November 21, 1985

Docket No. 50-346

LICENSEE: Toledo Edison Company
FACILITY: Davis-Besse Unit No. 1
SUBJECT: AUXILIARY FEEDWATER (AFW) RELIABILITY ANALYSIS MEETING,
OCTOBER 16 AND 17, 1985

SUMMARY OF RESULTS FOR DBNPS-1 AFHS CONFIGURATIONS

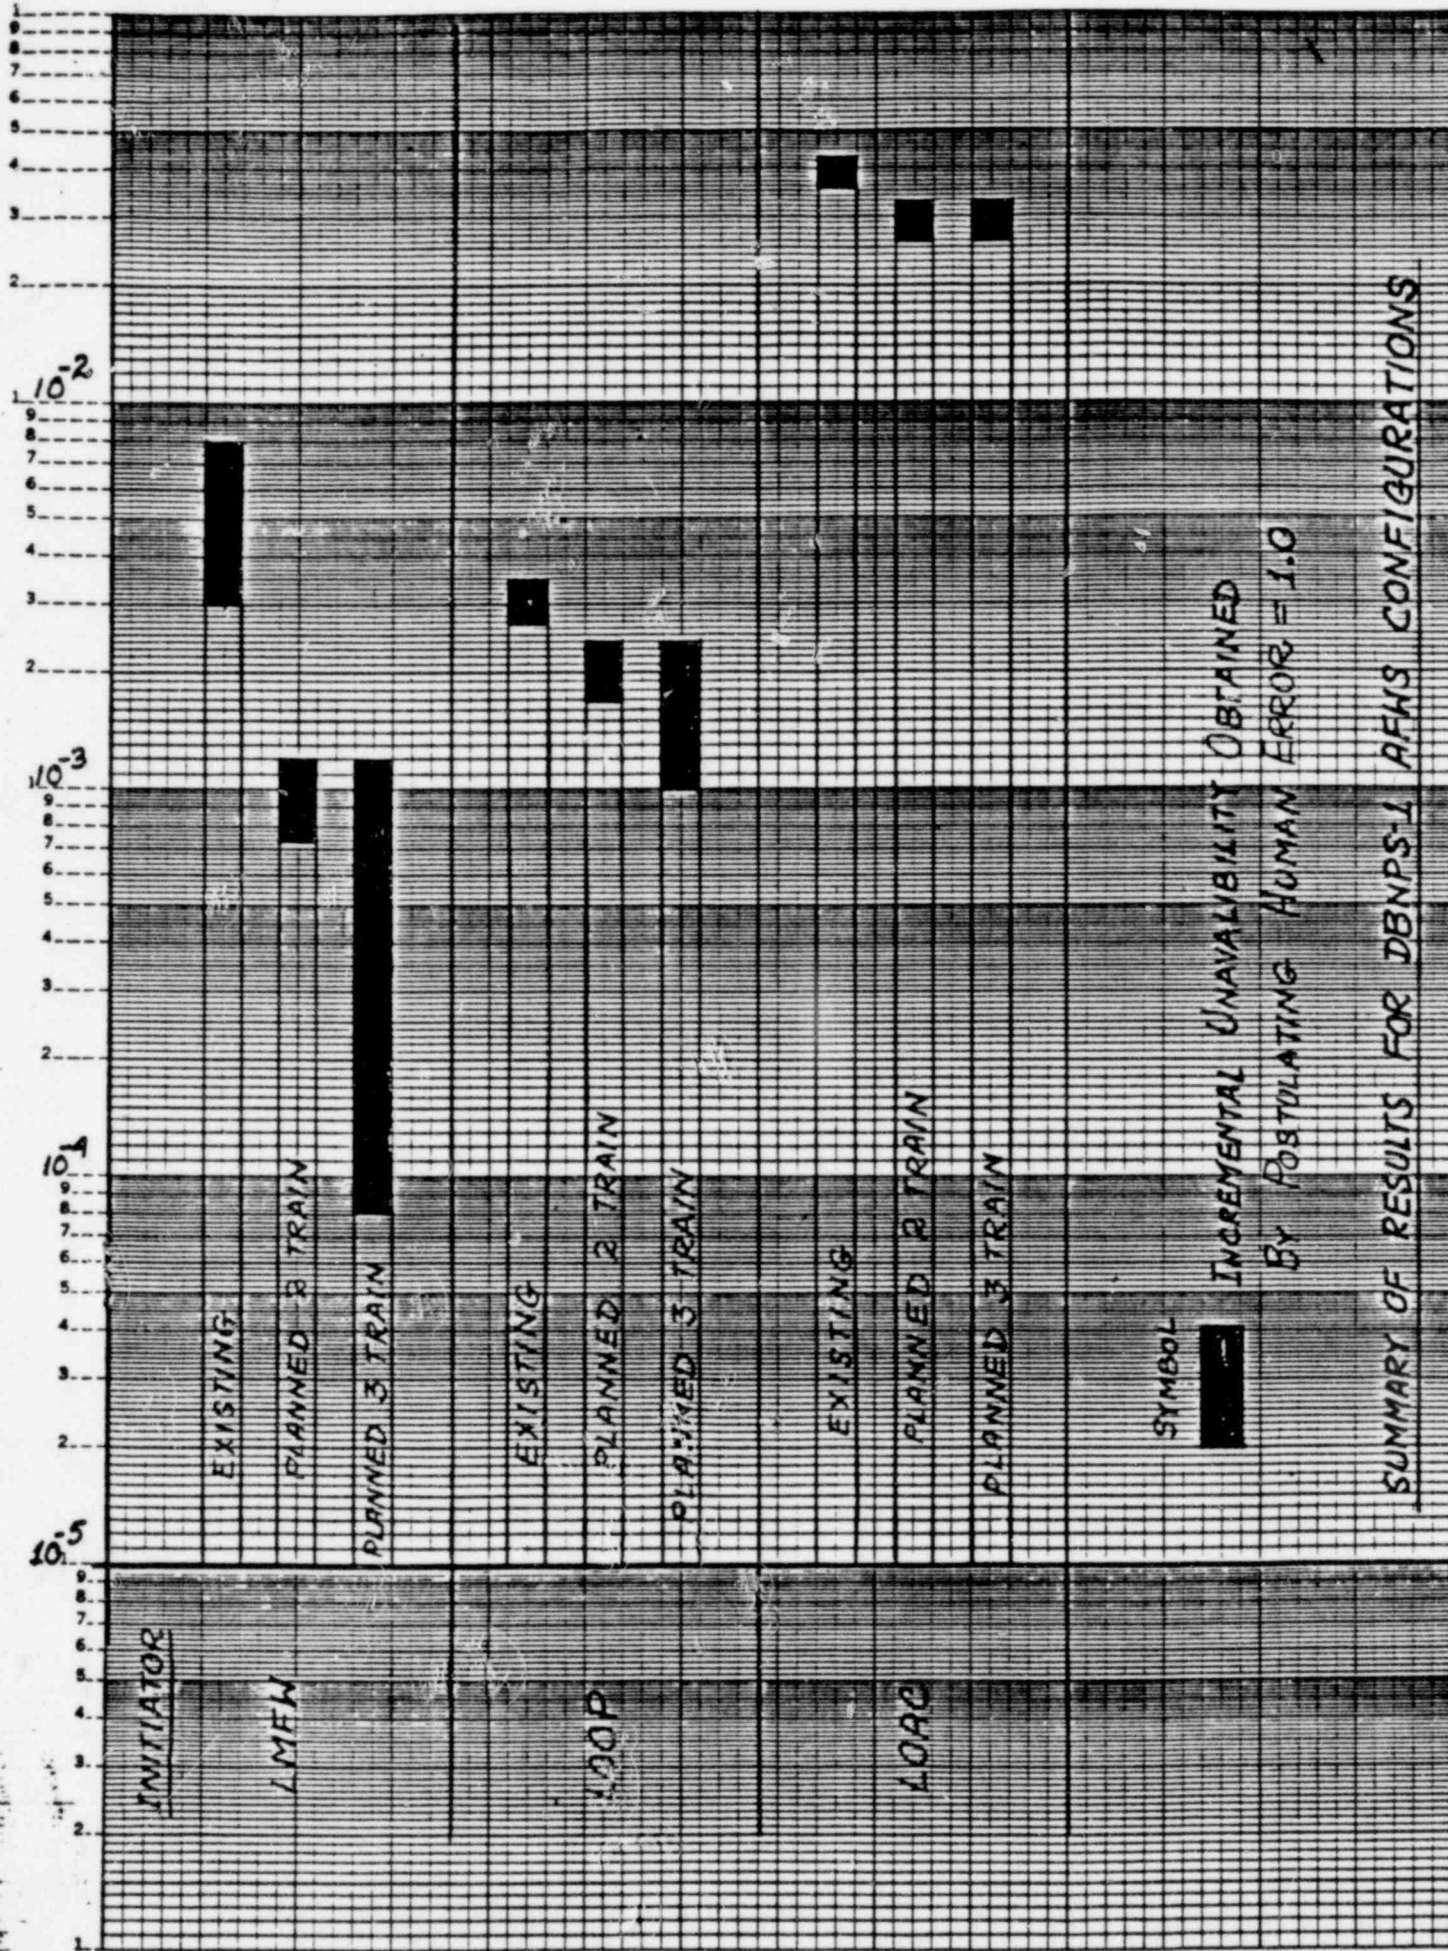
The licensee presented a summary of their AFW unavailability results (see last two pages of Enclosure 1). Additionally, they stated that the AFW reliability results would be docketed by October 25, 1985. For a loss of main feedwater event, the licensee predicts an unavailability of $\sim 8 \times 10^{-5}$ for the modified AFW system, allowing for operator action to start the new motor driven feed pump. The staff requested that justification be provided for each of the assumptions in their analysis.
